APPENDIX Q Comments and Responses on the Draft EIS

FERC's Responses to Comments on the Draft EIS

FA001 – U.S. Department of the Interior (includes USFWS & USGS comments)

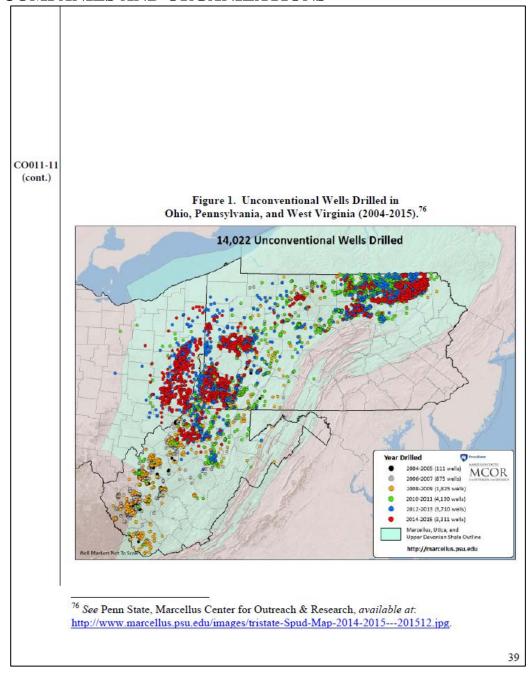
Moreover, FERC excluded the impacts of oil and gas production from its cumulative impacts analysis. FERC excluded these impacts despite "recognize[ing] that oil and natural gas exploration and production activities are *ubiquitous* in many of the counties crossed by the MXP" and involve similar construction methods that cause "erosion and sedimentation, and impacts on wetlands, waterbodies, and other natural resources." DEIS at 4-320 (emphasis added). The "ubiquitous" nature of shale gas production is evident in Figure 1.

Figure 2: Total Confirmed Bobcat Observations, 2006-2011.

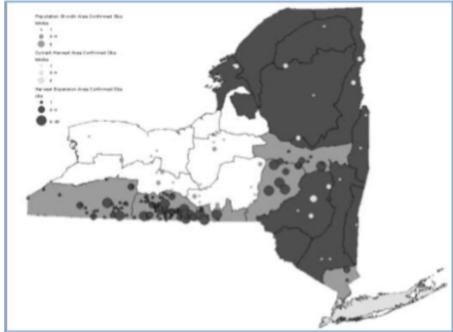
While NYDEC was documenting an increase in bobcat observations in the southern tier of New York between 2006-2011, hundreds and then thousands of shale gas wells were being drilled in the northern tier of Pennsylvania. See Figure 2 above. As Figure 2 indicates, between 2006-2011, gas companies drilled at least 4,858 shale gas wells in Pennsylvania. Many of these wells were drilled in Pennsylvania's northern tier. Thus, at the same time the gas industry began and then rapidly escalated gas drilling across the northern tier of Pennsylvania, the bobcat population in the southern tier of New York "increased dramatically." Since there has been no shale gas development in New York throughout this time period due to a moratorium (and now ban)⁷⁹ on

B. The DEIS Does Not Sufficiently Analyze Alternative Sites That Would Reduce the Environmental Impact of the Compressor Station.

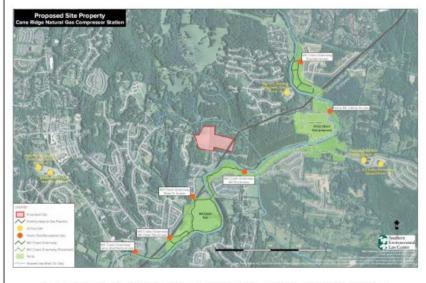
The DEIS does not meaningfully analyze alternative sites despite the fact that the Compressor Station is proposed for a neighborhood within the urban services district of Nashville next to schools, parks, and homes:

U.S. Census: Total Population Density (Foreign Born) by Census Tract with Proposed Compressor Station Location Indicated

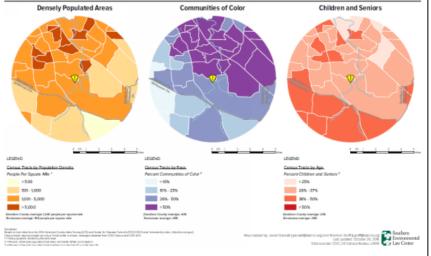
Second, at the census tract level, the site proposed by TransCanada is more densely populated, has more communities of color, more children and seniors who are susceptible to the Compressor Station's impacts, and more immigrants and refugee populations.

CO012-34 (cont.)

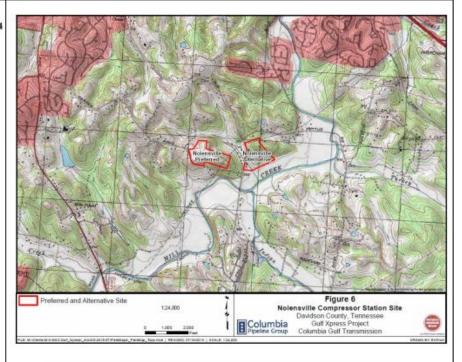
Based on the grading of the site, additional review is needed in a revised DEIS.

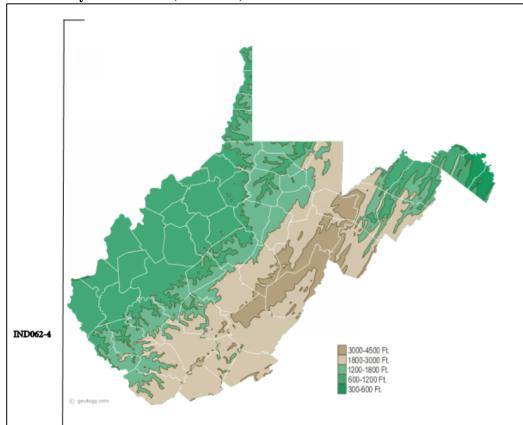
Confoundingly, the DEIS says, "...the MXP is in higher-elevation mountainous areas, where the start of the nesting season is sometimes delayed compared to lower-elevation regions in the state..." The MXP does not cross high elevation areas of West Virginia. [see elevation map, below]
